Addendum 1 for RFB927920-01

Project Name: WRC Decentralization Phase 2 & Fire Alarm & Myers Hall Sprinkler
DAS RFB #: 927920-01
DAS Project #: 9279.20-21 & 9294.00
Date: 2/16/2023

STATE HISTORICAL PRESERVATION OFFICE REQUIREMENTS:

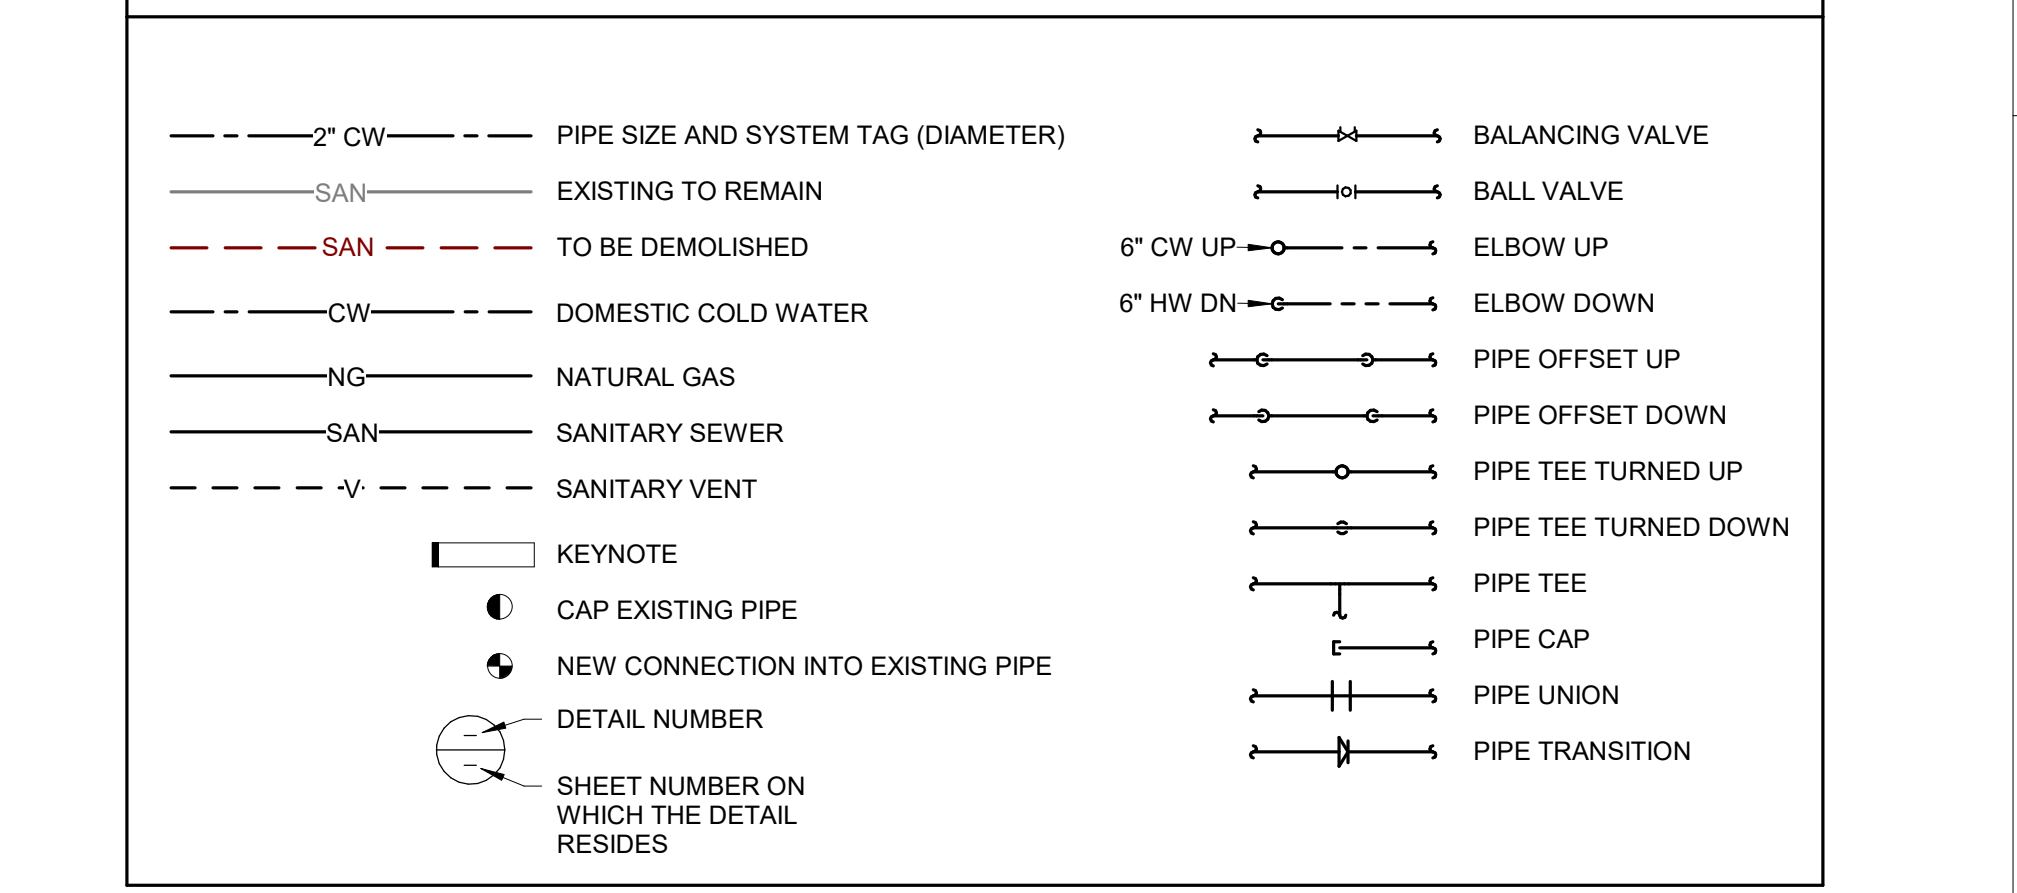
- **00-MP00 – MECHANICAL & PLUMBING GENERAL INFORMATION**
 - **ADD** section outlining State Historical Preservation Office Requirements
- **00-E000 – ELECTRICAL GENERAL INFORMATION**

- FOR FINISHED SPACES (OFFICES, RECEPTION, ETC.), PAINT EXPOSED PIPING WHITE.
- FOR UNFINISHED SPACES (BASEMENTS, ATTICS, WORKSHOPS, ETC.) PIPING CAN REMAIN UNPAINTED.
- FOR SPACES WITH WOOD CEILINGS (NATURAL COLOR) IN MYERS HALL PAINT EXPOSED PIPING NEXT TO WOOD CEILINGS BROWN. FOR EXPOSED PIPING IN THE REST OF THE ROOM, PAINT AS DESCRIBED IN FINISHED SPACES.

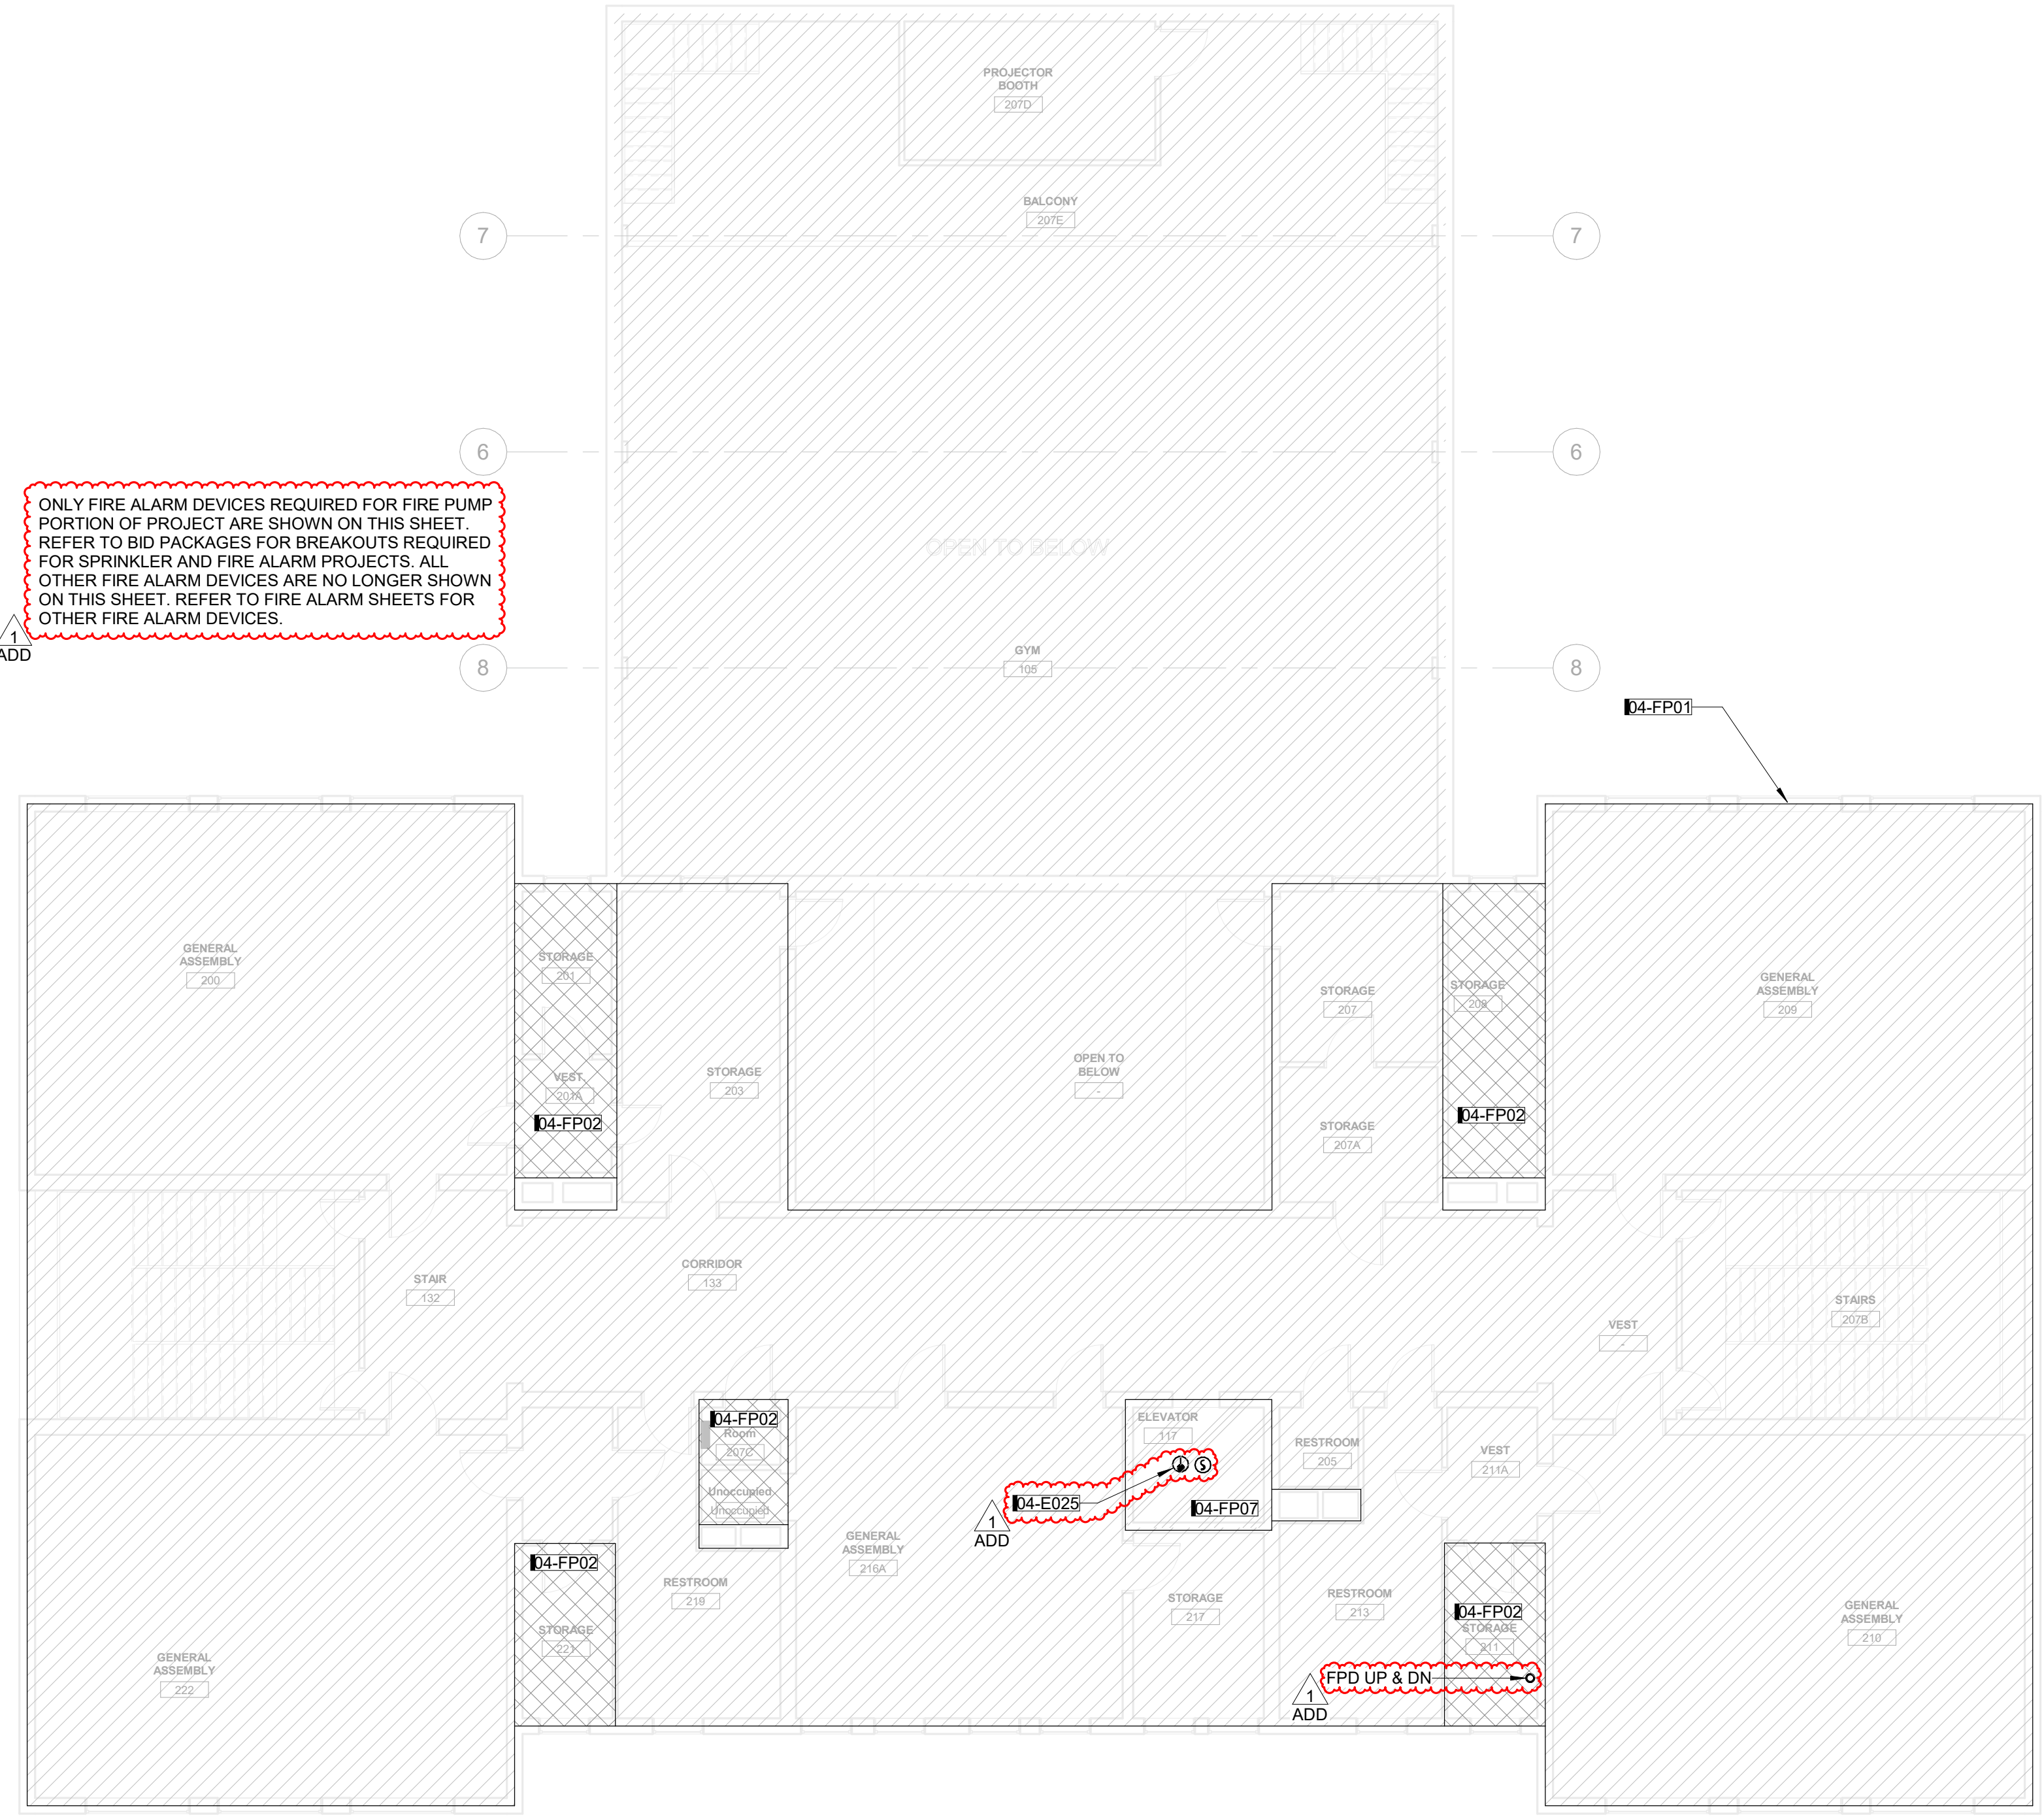
- **04-FP102 - SECOND FLOOR FIRE PROTECTION PLAN**
 - **REVISE** notes 18 and 19 to read “NOT USED.”
 - **ADD** dry system riser to sheet.
 - **ADD** keynote 04-E025 to sheet.

1 ATTIC FIRE PROTECTION PLAN
1/8" = 1'-0" 0 12'

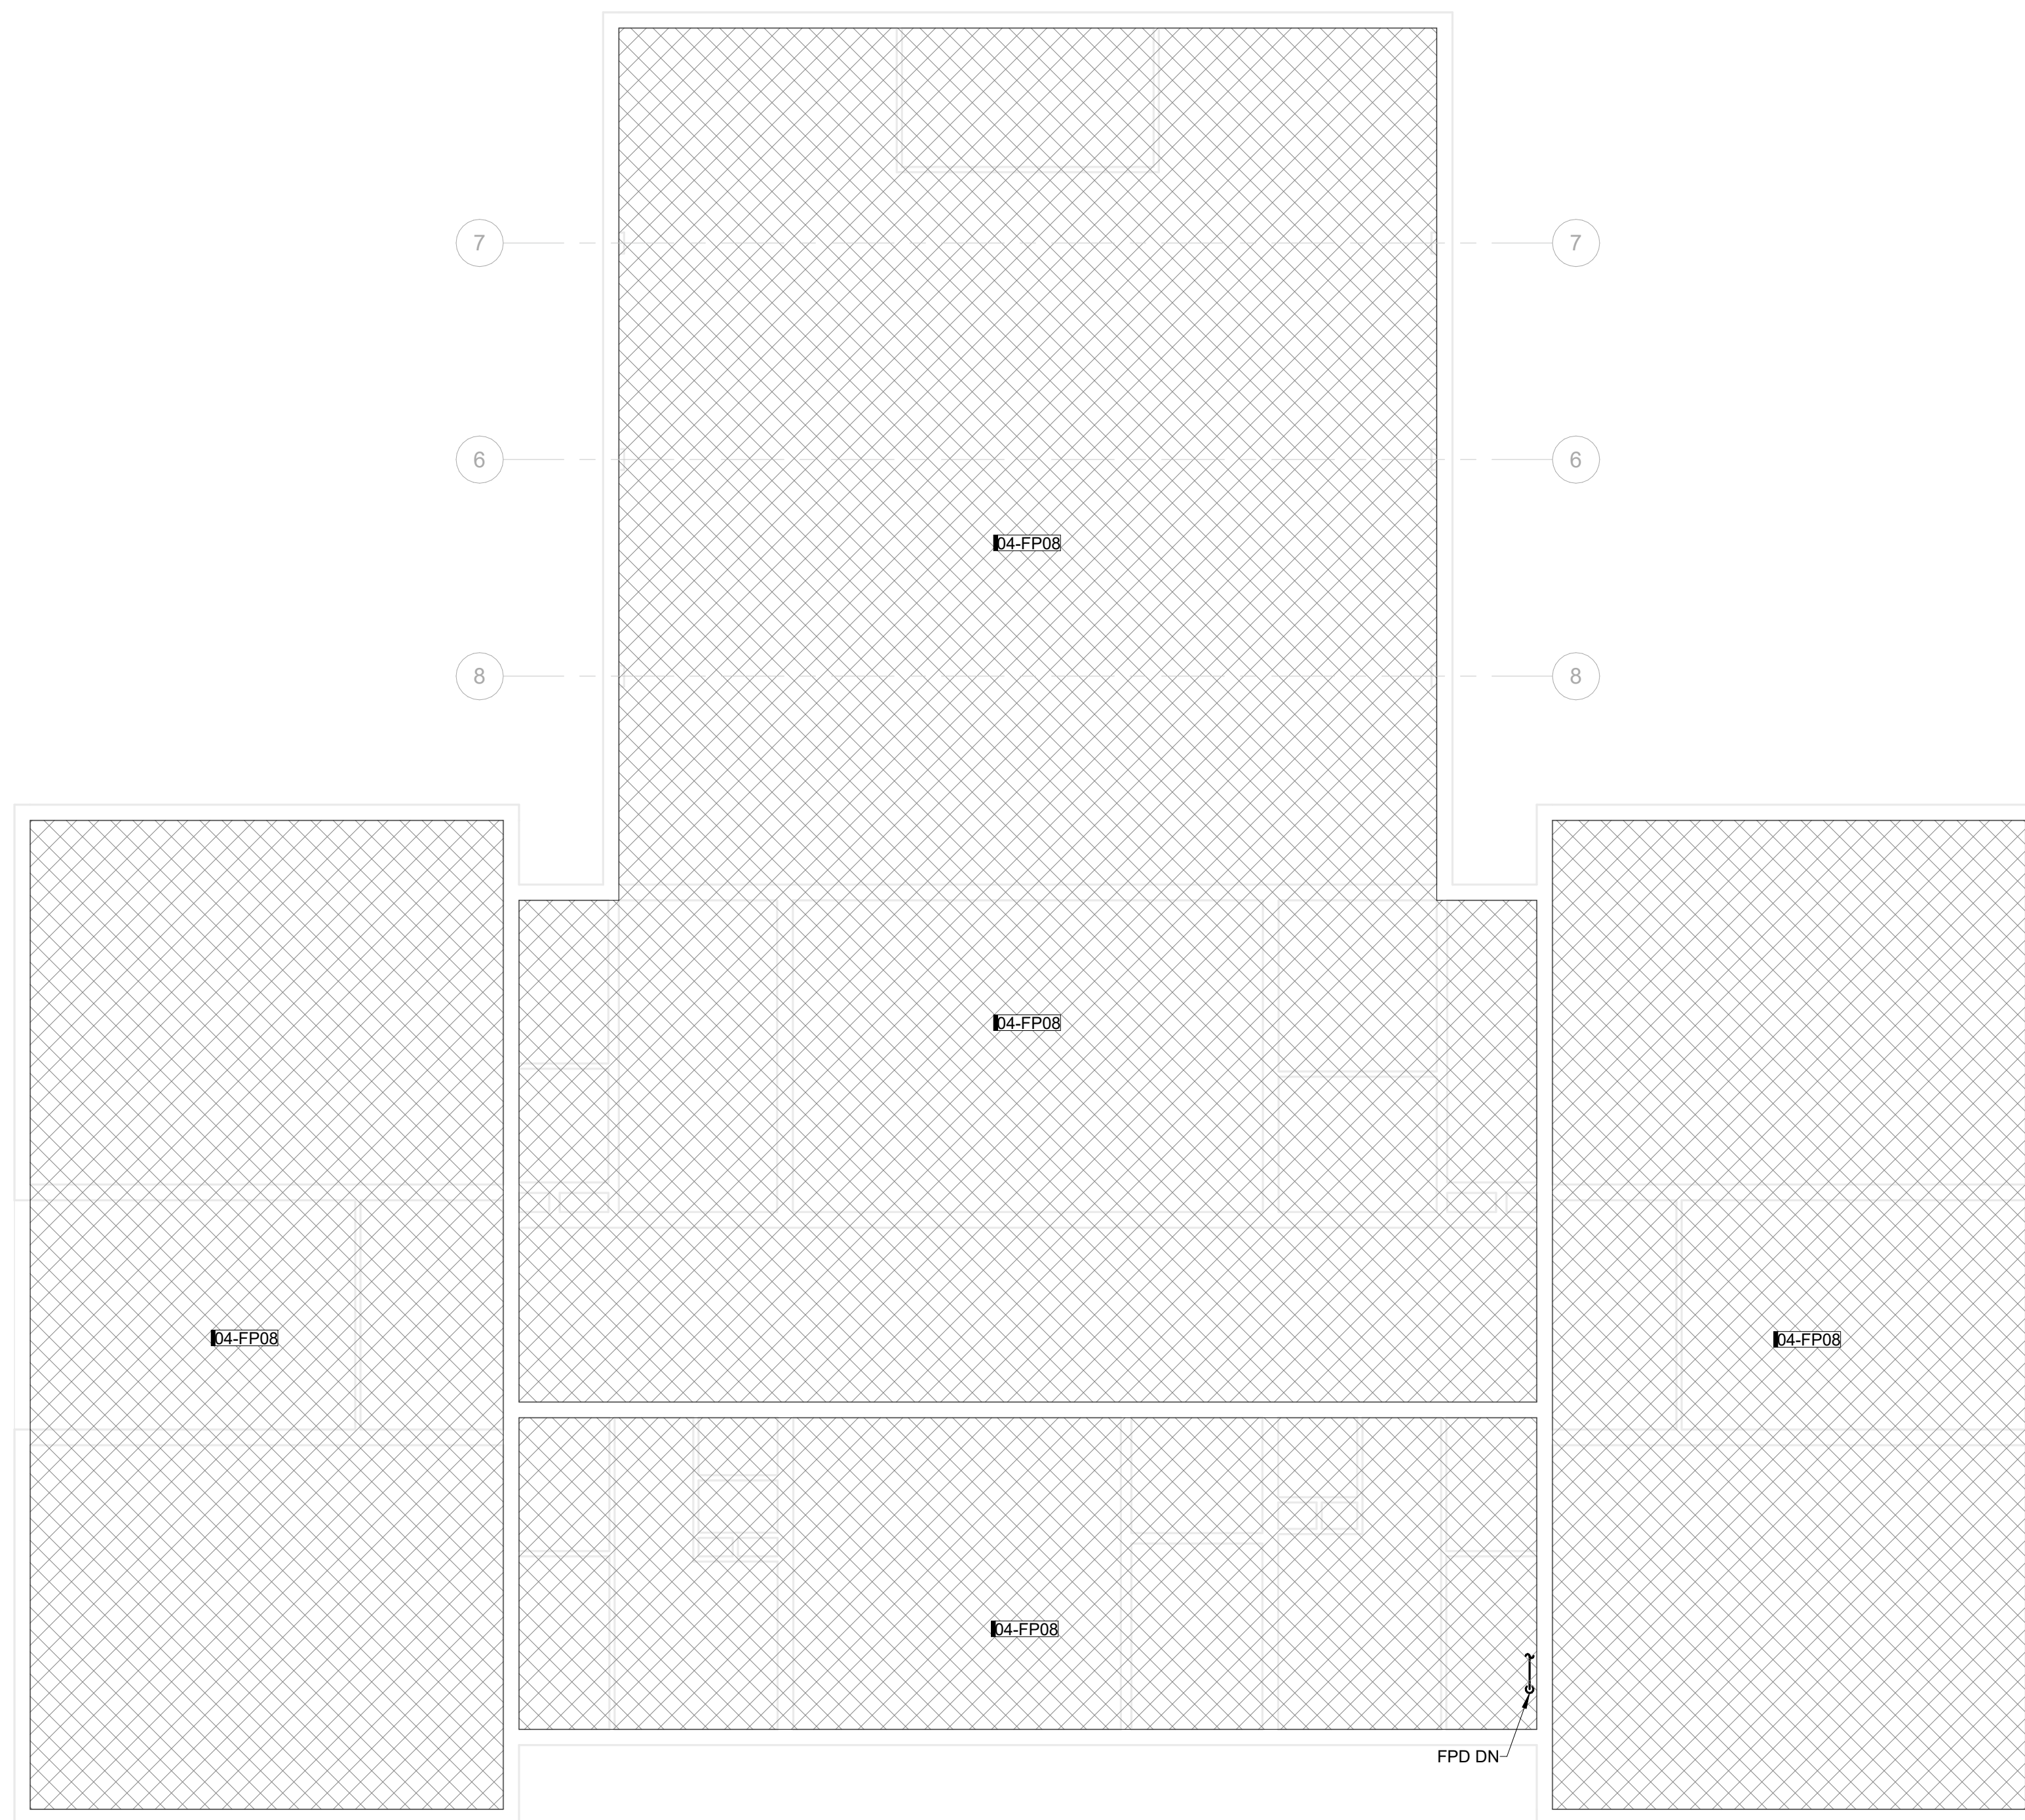
Q1. Is there an attic at Myers Hall that needs to be sprinklered?

- **04-FP103 - ATTIC FIRE PROTECTION PLAN**
 - **ADD** sheet to project.
- **04-FP300 - FIRE PUMP PLANS, DETAILS & SCHEDULES**
 - **REVISE** SPRINKLER RISER DIAGRAM to show dry sprinkler riser.

A1. Yes, please see attached drawing sheet 04-FP103.
